Access Compliance Report

Public Rights-of-Way

Intersection ID: 3565	Main Street: ROTHERHAM_LN	Cross Street: TREYBURN_DR	Location: NW
ADA ID: 0759DBEB6900	Ramp Type: Perp	Initial Pass/Fail: Fail	Overall Compliance: No
		Severity Score: 12.5

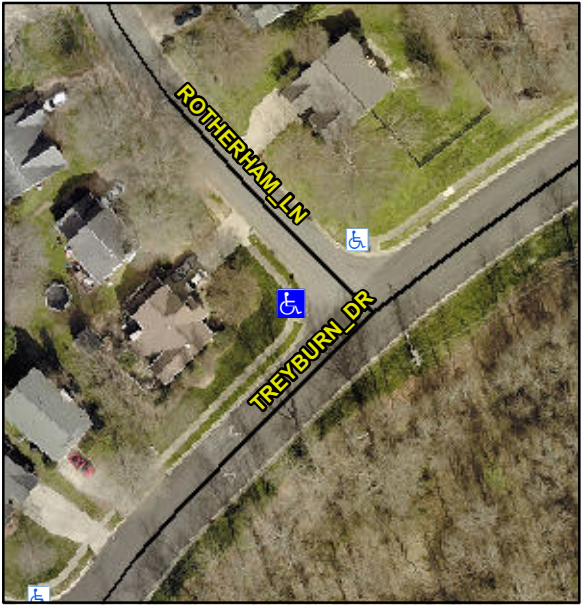
Codes/Mitigation Info/Possible Solution			Field Measurements/Component Compliance		
	Possible Solutions:		Compliance	Description	Data
	Remove & Replace Entire Ramp.		No	Ramp Length (in)	54.0
			Yes	Ramp Width (in)	48.0
			N/A	Flare Type LT	N/A
			N/A	Flare Slope LT (%)	N/A
			N/A	Flare Traversable LT?	N/A
			N/A	Landing Length (in)	N/A
			N/A	Landing Width (in)	N/A
			N/A	Landing Slope (%)	N/A
			N/A	Landing X Slope (%)	N/A
<p>Surveyor Notes:</p> <p>N/A</p> <p>PROW/ADA:</p> <p>Not Found, R304.2.2</p>			N/A	Flare Type RT	N/A
			N/A	Flare Slope RT (%)	N/A
			N/A	Flare Traversable RT?	N/A
			N/A	DWS Provided?	N/A
			N/A	DWS Contrast?	N/A
			N/A	DWS Length (in)	N/A
			N/A	DWS Full Width?	N/A
			N/A	DWS Offset (in)	N/A
			N/A	Shared Landing?	N/A
			N/A	Gutter Ponding?	N/A
			N/A	Gutter Lip Ht (in)	N/A
			N/A	Painted X Walk1?	No
				X Walk 1 Direction	To NE
			N/A	X Walk 1 Width (in)	N/A
				X Walk 1 Slope (%)	1.3
				X Walk 1 X Slope (%)	0.6

N/A	Ramp inside XWalk1?	N/A
			N/A	Road Slope (%)	N/A
			N/A	Road X Slope (%)	N/A
			N/A	Any Obstructions?	N/A
Total Cost:		\$ 1850.00		Obstruction Type	
			N/A	Storm Grate/Utility Hazard?	N/A
				Storm Grate/Utility Type	
			N/A		N/A
			Yes	Surface Condition? (G/P)	Good
